Re: 7126 Wisconsin Avenue – Sketch Plan Amendment No. 32019003A, Preliminary Plan of Subdivision No. 120230020, and Site Plan Application No. 820230020 (collectively, the “Applications”) – Cover Letter to Accompany January 2024 Resubmission

7126 wisconsin avenue
bethesda, maryland

minor dap revision

design adjustments / previous dap reviews / site plan approval

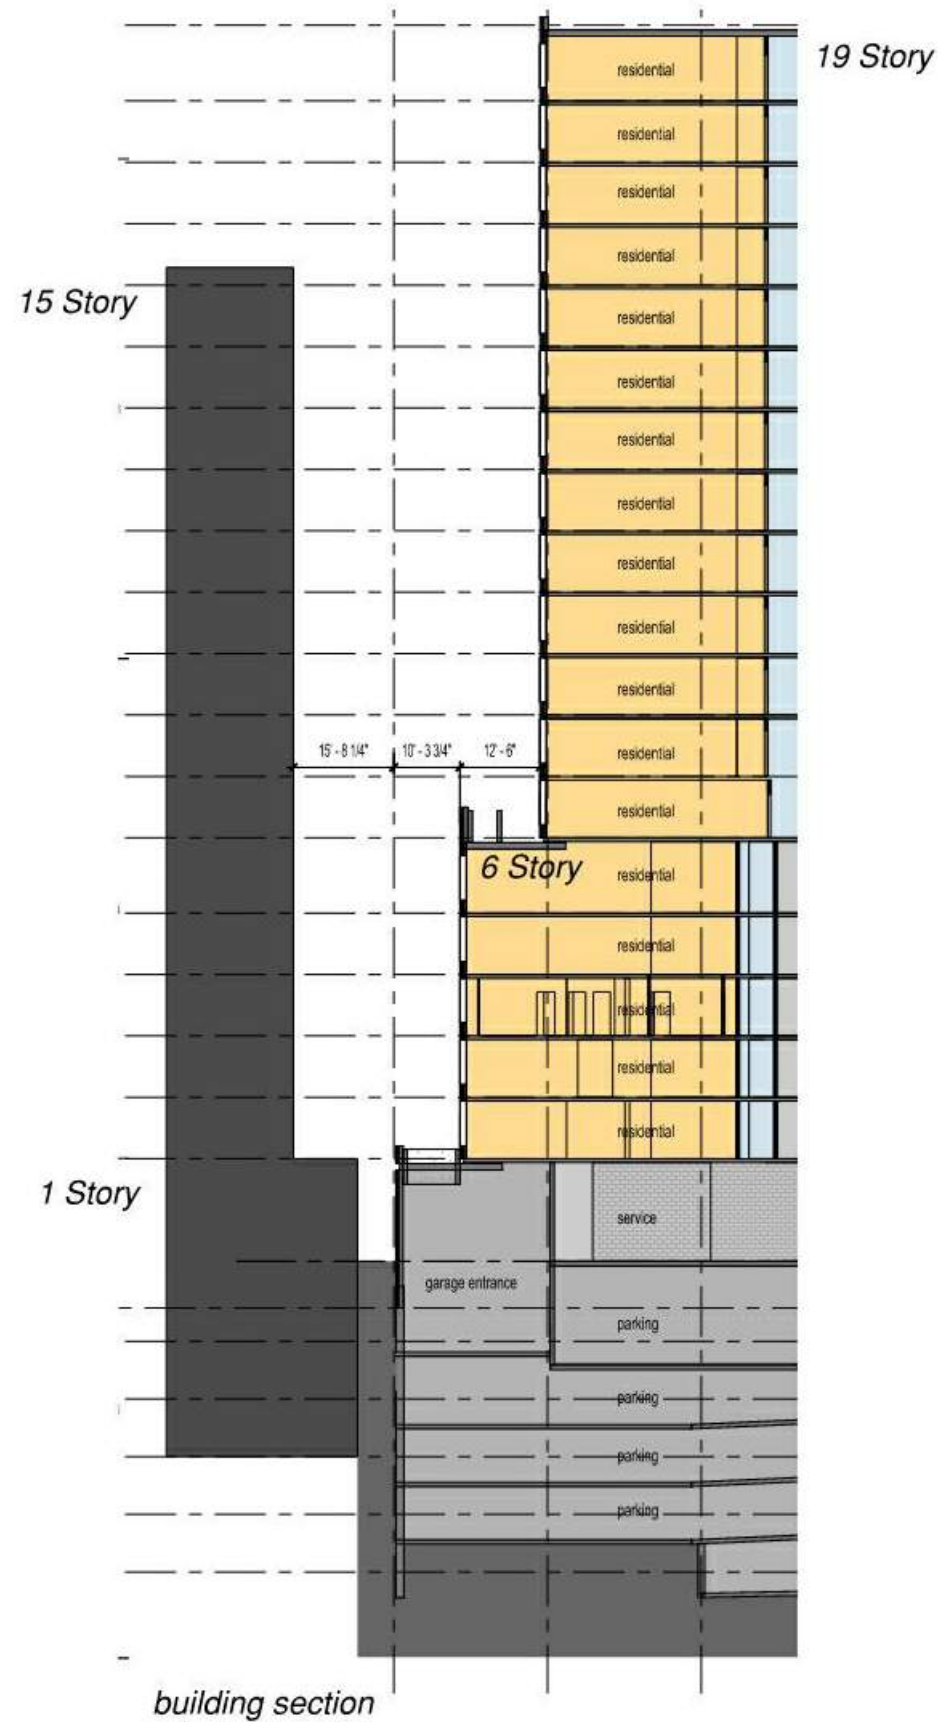
Per discussions with the adjacent property owner of "The Seasons" apartment building, the proposed building plan and facades have been adjusted as such:

- the area affected is along the west property line adjacent to "The Seasons"
- the buildings "base" has been:
 - stepped-back 10' above the 1st Floor
 - affects floors 2-6
 - additional windows added along the west facade
- the Green Cover has been redesigned to meet the 35%
